SUTHERLAND SHIRE COUNCIL ASSESSMENT REPORT

Panel Reference	(PPSSSH-62)
MA Number	21/0051
LGA	Sutherland Shire Council
Approved Development	Refurbishment and restoration of Heathcote Hall, construction of 35 townhouses and 20 apartments, associated landscape works and 56 lot strata subdivision
Proposed Modification	S4.55(2) Modification to DA17/0467 – Deletion of basement level commercial car parking, architectural design changes, design changes as required by conditions of consent, amend condition 10 and delete condition 30(xvi)
Street Address	Lot 1 DP 725184, Lot 2 DP 725184, 1-21 Dillwynnia Grove, Heathcote
Applicant/Owner	Pariter Pty Ltd Heathcote Grounds Pty Ltd
Date of DA lodgement	18 February 2021
Number of Submissions	15
Recommendation	Approval
Regional Development Criteria (Schedule 7 of the SEPP (State and Regional Development) 2011	The original application was referred to the SSPP has a capital investment value (CIV) of more than \$20 million and is nominated under Schedule 4A (3) of the Environmental Planning and Assessment Act 1979 (i.e. CIV of \$29,500,474.00). The s.4.55(2) modification application is referred to the SSPP as more than 10 unique submissions were recei

Figure: Townhouses 1 -3 fronting Boronia Grove (NW site corner)

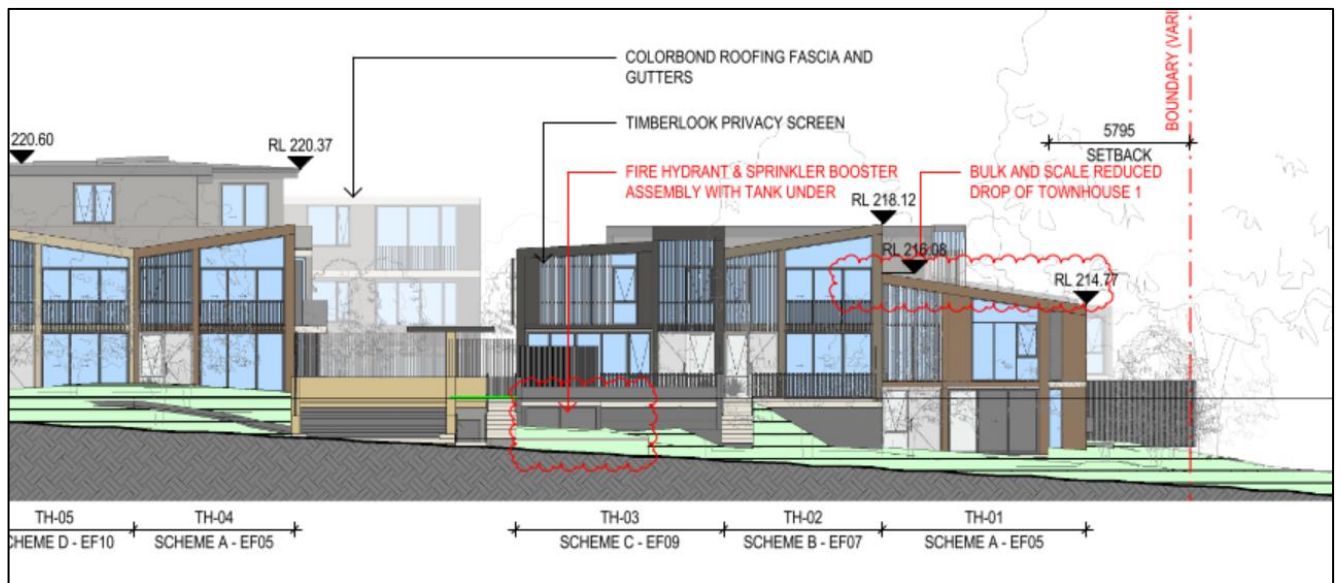
The proposal comprises design changes which are intended to improve the overall functionality of the development and associated residential amenity. The design amendments result in a reduction in the approved building height for Townhouses 1, 14, 15, 16, and 17 and the façade height of Apartment Building B. Townhouse 1 is reduced in height by approximately 200mm and Townhouses 14-17 are reduced by approximately 1m. The reduced bulk and scale of the proposal as presented to the Boronia Grove streetscape and surrounding properties is acceptable. The proposed layout changes to the individual townhouses and units improve their overall design, function and amenity for future residents.

Plans have been amended denoting hydrant infrastructure including the hydrant booster assembly generally consistent with the design conditions of consent. The application indicates that the conditioned fire rated wall is, however, not provided as a performance solution is being prepared by a fire engineer in consultation with Fire and Rescue NSW. Council is recommending a condition is imposed as specified in Appendix A requiring written satisfaction of Council to ensure the visual impact upon the streetscape of Boronia Grove remains acceptable in the event any deviation from the approved Architectural Plans is required (e.g. should changes to the size be required or if a wall / shield or FRNSW emergency vehicle hardstand is required).

Figure: Townhouses 14 – 17 fronting Boronia Grove / Tacoma Street (NE site corner)

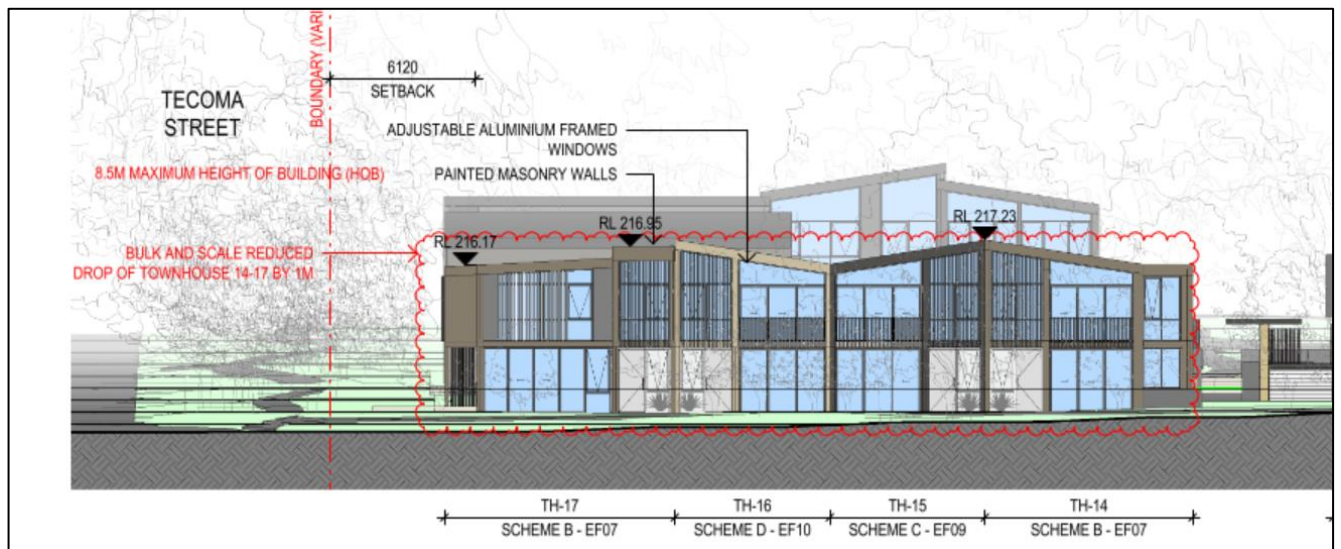
- *Further Proposed design changes as described by the statement of environmental effects including :*
 - Dropping of FFL of Townhouse 1.
 - Dropping the FFL of Townhouses 14-17 by 1m.

Figure: South Elevation apartment Building B

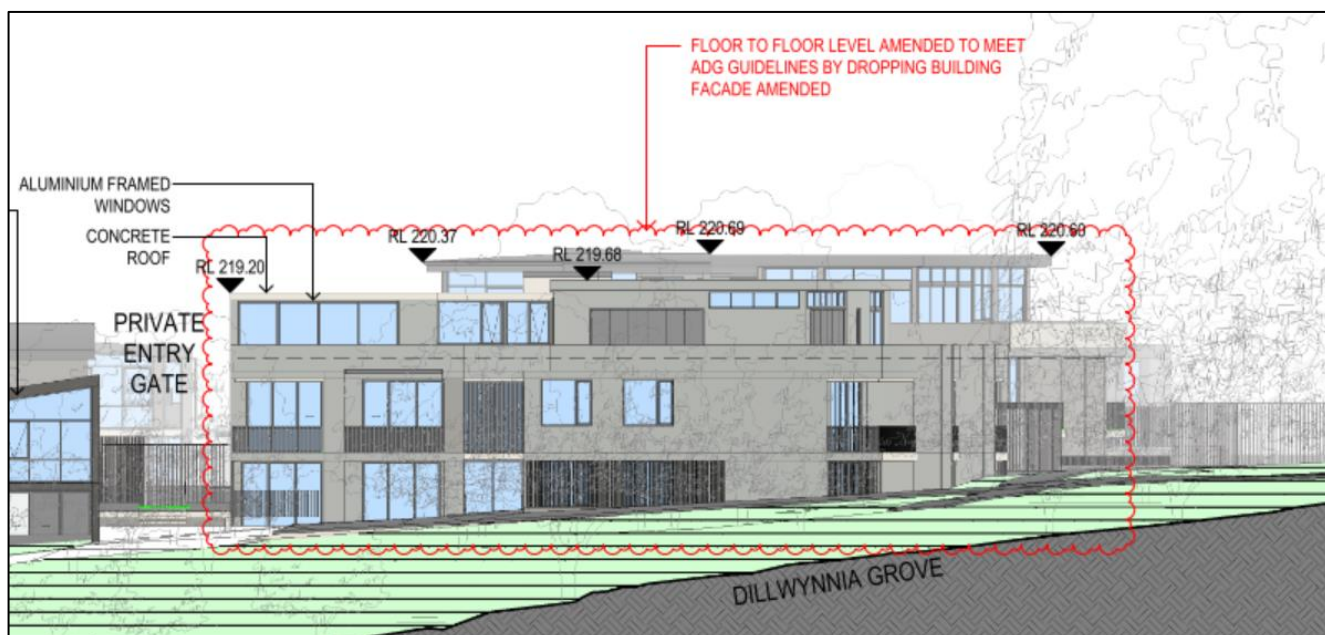
Design changes to Apartment Buildings A and B are anticipated to facilitate improved solar access with the provision of additional windows and facades amendments. No significant visual privacy / overlooking impact to adjoining properties or to dwellings within the development is anticipated to any unacceptable degree. The floor-to-floor level within Apartment Building B is increased by dropping the lower floors while maintaining the building height below the approved 9.5m height of building, improving internal amenity of these apartments.

The proposed design changes are contained wholly within the approved building footprint. The bulk and scale of the development is reduced and proposed layout changes to the individual townhouses and units improve design, function, and amenity for future residents. The design changes will not result in any additional overshadowing or visual impacts than originally approved and the proposed amendments do not detract from the heritage significance of Heathcote Hall and the adjoining grounds.
